CHATHAM COUNTY ZONING BOARD OF APPEALS MPC

STAFF REPORT

PETITIONER: Micheal Ross
FILE NO: ZBA-0925-000585
ADDRESS: 23 Penrose Drive
PIN: 10117 01010
DATE: January 27, 2026

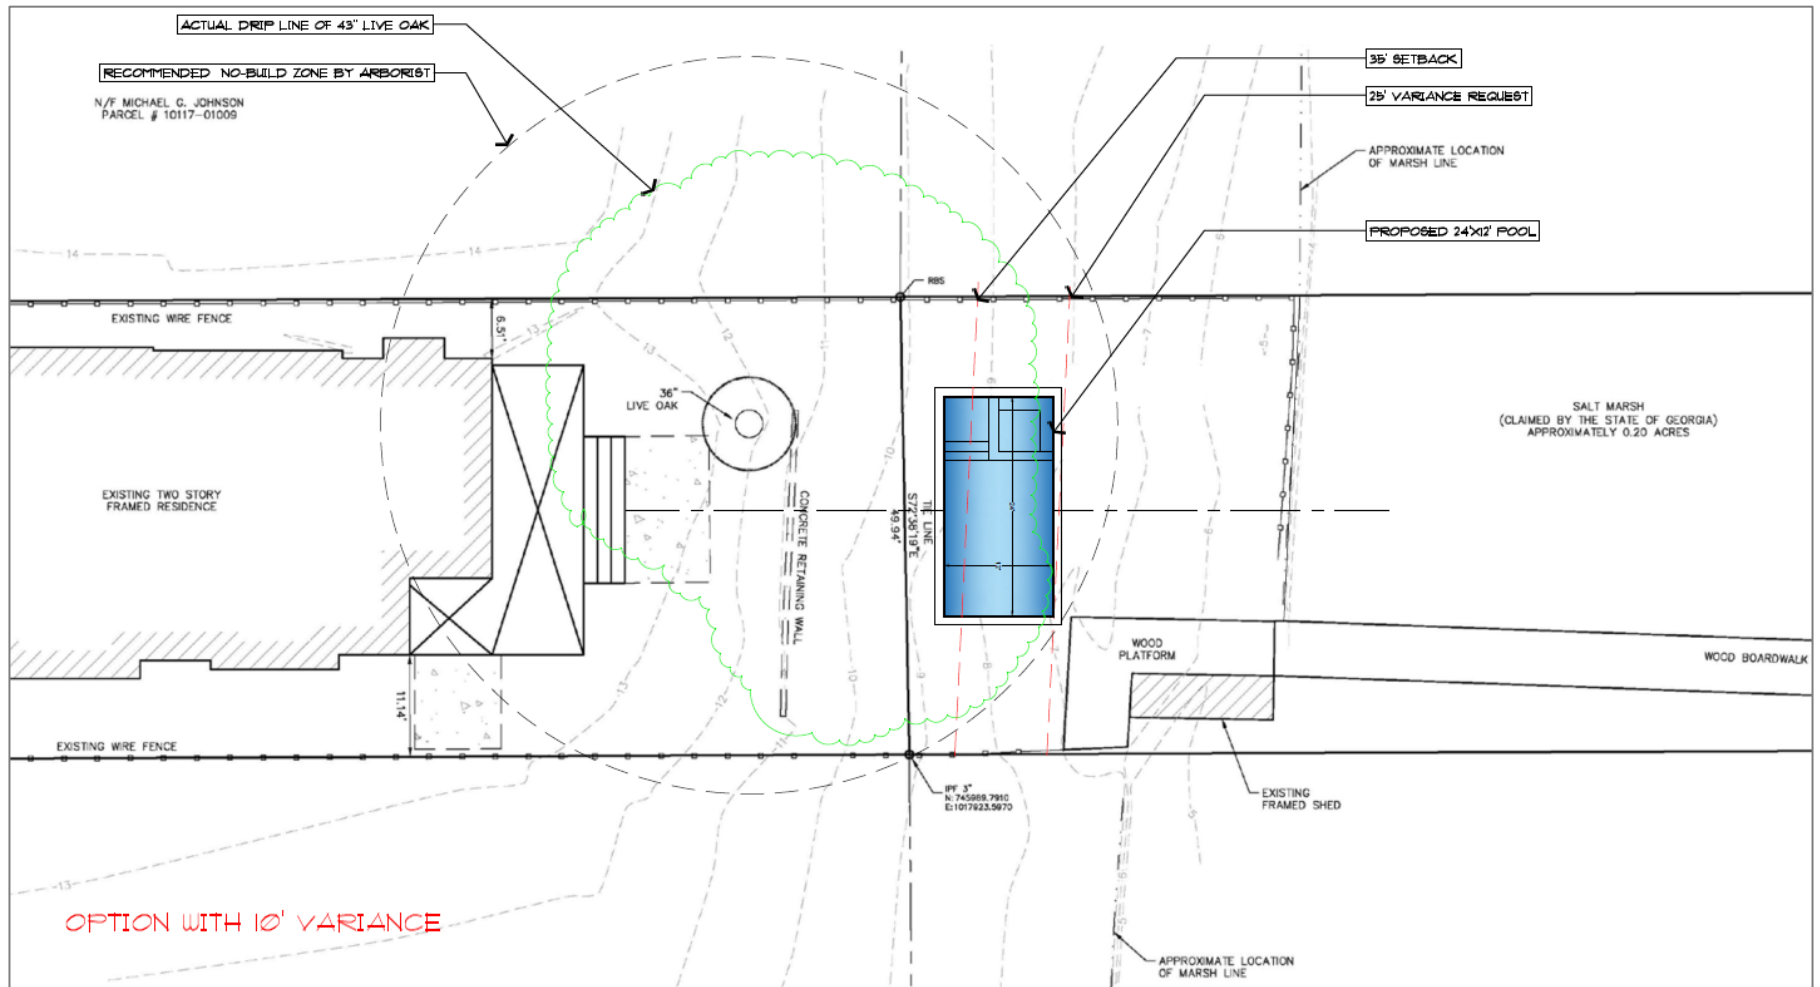
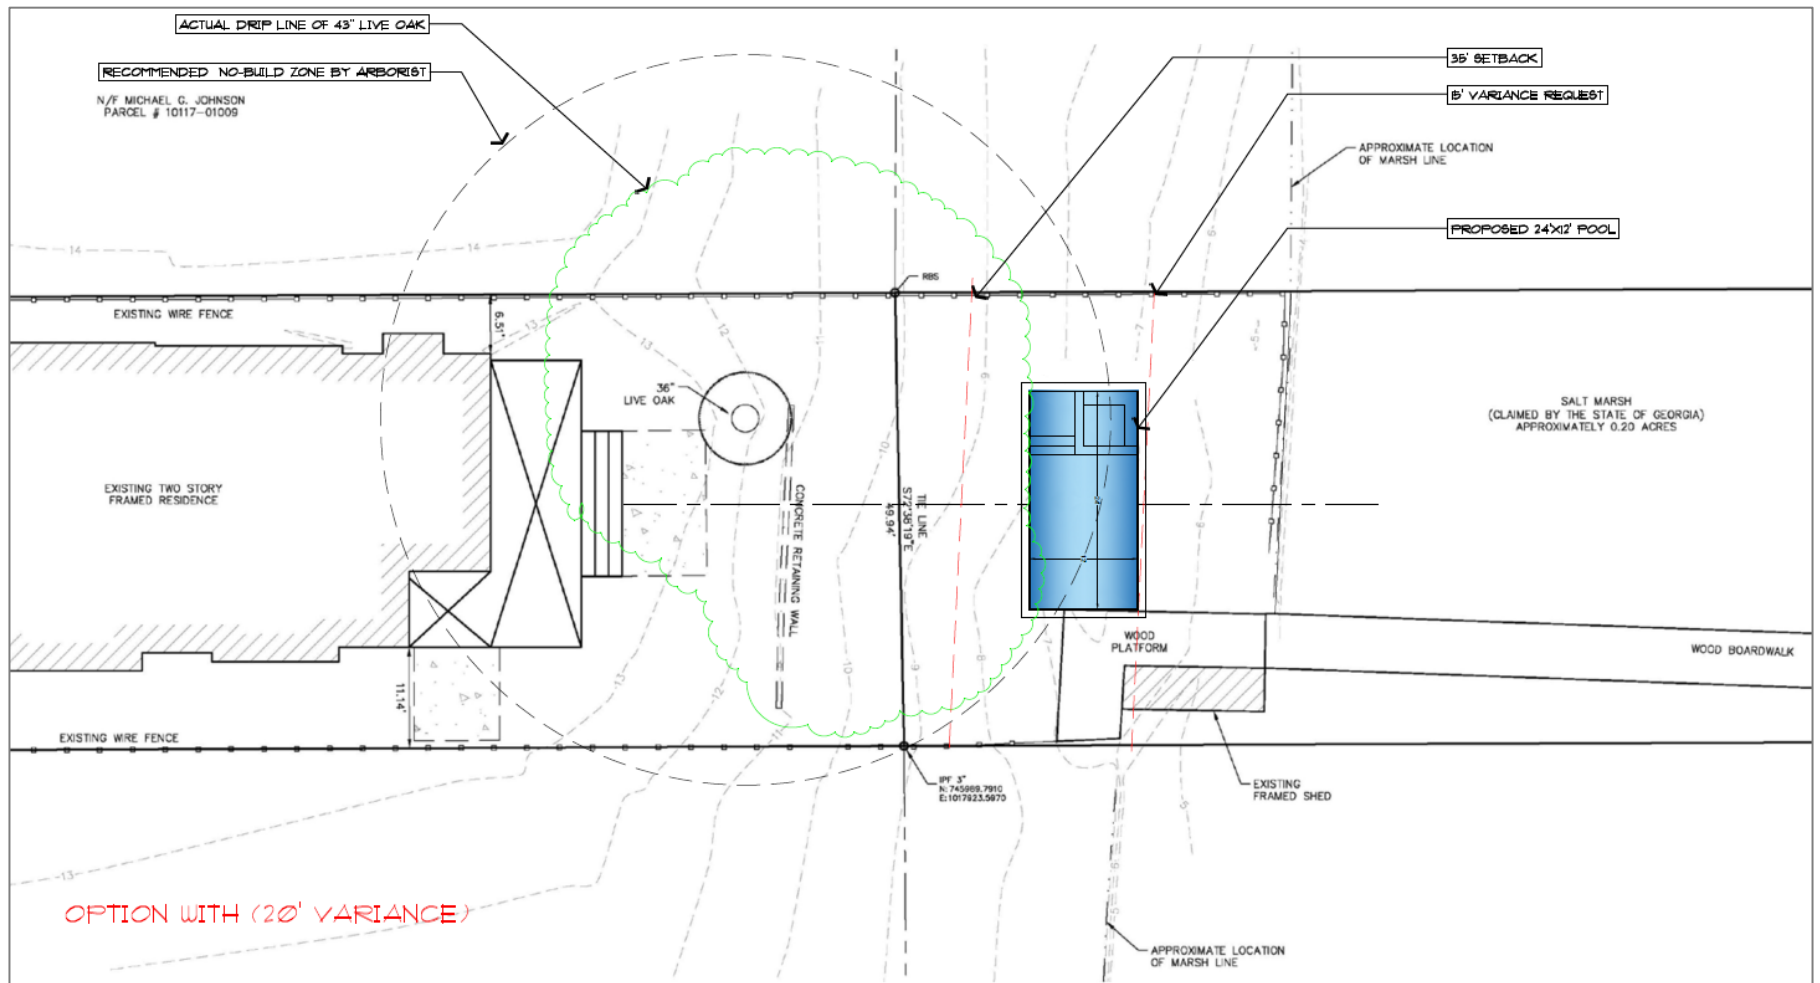
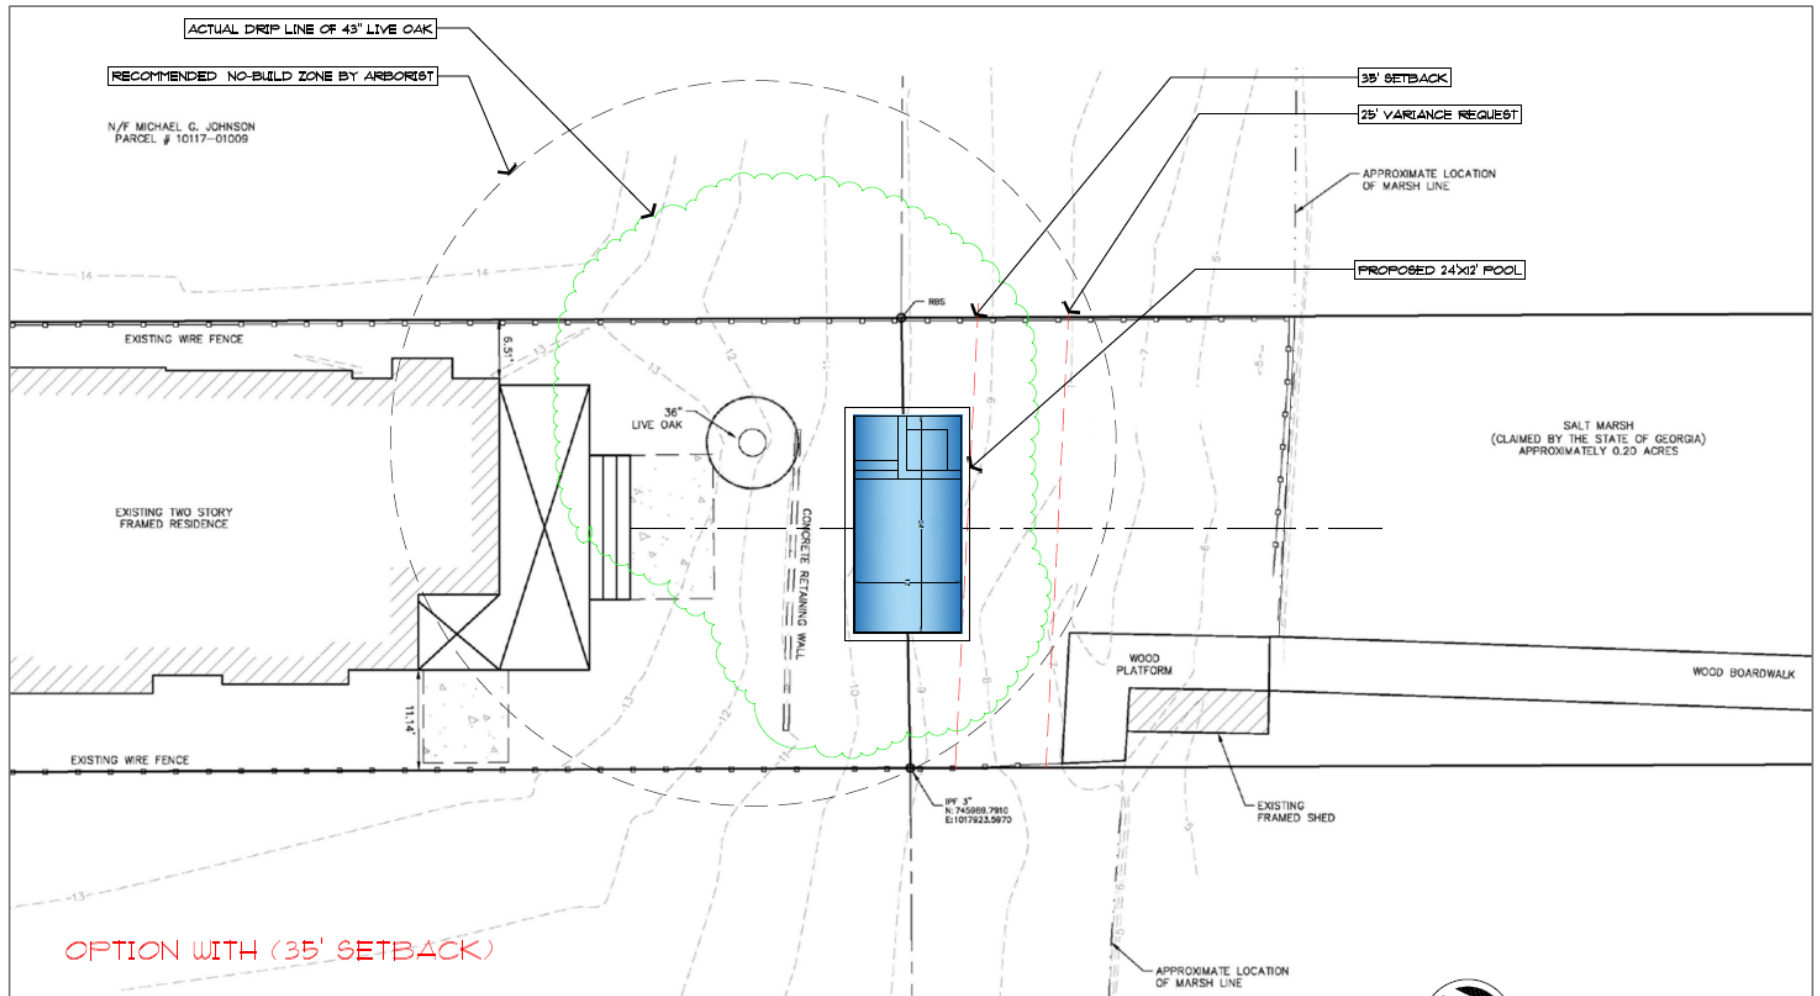
The petitioner initially appeared before the CZBA on October 28, 2025, requesting a variance to reduce the required 35-foot riparian buffer setback to 10 feet in order to construct a pool in the rear yard. The request was attributed to the presence of a mature live oak tree on the property, as locating the pool outside the buffer was expected to disturb the tree's root system.

During the public hearing, the CZBA recommended that the applicant reevaluate the pool design and location to minimize impacts to both the riparian buffer and the live oak tree, and to return with a revised proposal at the January 27, 2026 CZBA meeting.

Following this re-evaluation, the applicant has submitted two alternative design concepts, both of which continue to require variances to encroach into the riparian buffer. The revised requests include:

1. A variance to reduce the required 35-foot riparian buffer setback to 10 feet (original request); and
2. A variance to reduce the required 35-foot riparian buffer setback to 20 feet.

The Petitioner is requesting a variance to Chatham County's 35-feet of riparian buffer. During the public hearing, the CZBA recommended that the applicant reevaluate the pool design to reduce impacts to the marsh buffer and the live oak tree and return with a revised proposal at the January 27, 2026 CZBA meeting. Following this re-evaluation, the applicant submitted revised concepts but continues to request a variance to reduce the required 35-foot marsh buffer setback to 10 feet, with an alternative option proposing a 20-foot setback. The hardship cited is the inability to construct the pool outside the buffer without compromising the health of the Live Oak tree.

While the proposed variance would allow encroachment into the 35-foot riparian buffer, the applicant has stated that it is intended to preserve the roots of a mature Live Oak tree by avoiding construction in other parts of the lot. However, the project still involves grading within the buffer area and the tree protection zone to install the pool and may damage the root system of the tree. Although the marsh itself will not be directly impacted, the encroachment does reduce the width of the protected buffer and may affect its intended function.

MPC staff recommends **approval** of the variance to reduce the required 35-foot setback from the marsh bulkhead to 10 feet to allow for the construction of a pool in the rear yard.
